UNITED STATES PATENT AND TRADEMARK OFFICE

APPLICATION NO.	FILING DATE	FIRST NAMED INVENTOR	ATTORNEY DOCKET NO.	CONFIRMATION NO.
10/554,404	10/24/2005	Shohichi Nitta	R2184.0470/P470	4485
24998	7590	10/26/2007	EXAMINER	
DICKSTEIN SHAPIRO LLP			LAXTON, GARY L	
1825 EYE STREET NW			ART UNIT	
Washington, DC 20006-5403			PAPER NUMBER	
			2838	
			MAIL DATE	
			DELIVERY MODE	
			10/26/2007	
			PAPER

Office Action Summary

DETAILED ACTION

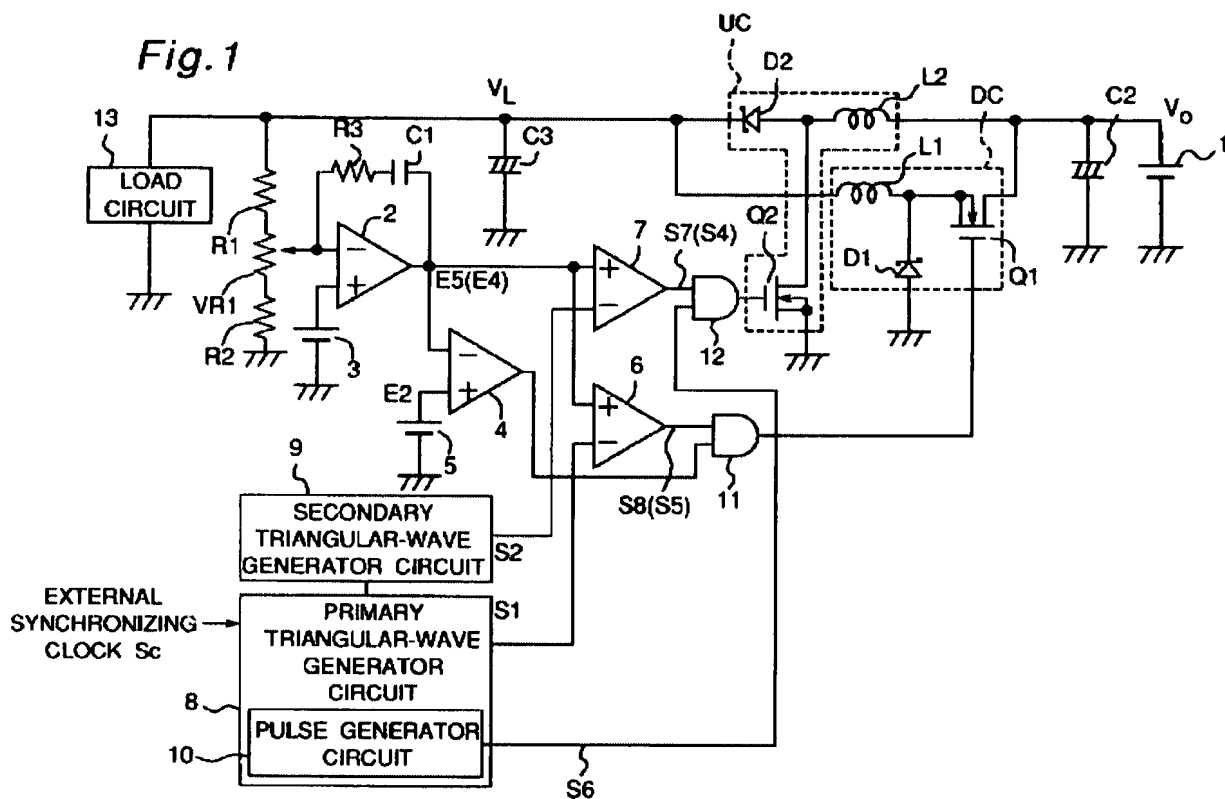
"Furthermore, Yasuda et al. discloses that the output battery voltage V_o is not divided or compared to a reference voltage, rather it is output directly. See FIG. 1. Applicants respectfully submit that Yasuda et al. does not disclose, teach, or suggest, as recited in claims 1, 7, and 13-14."

One of ordinary skill in the art readily recognizes that the battery voltage V_o in figure 1 is NOT the output. This is evidenced by the fact that element 13 illustrates "LOAD CIRCUIT" (13). Hence, V_o is the INPUT and not the OUTPUT. Load circuit 13 is the output. Therefore, the output is divided by $R1$, $R2$ and compared to a reference 3.
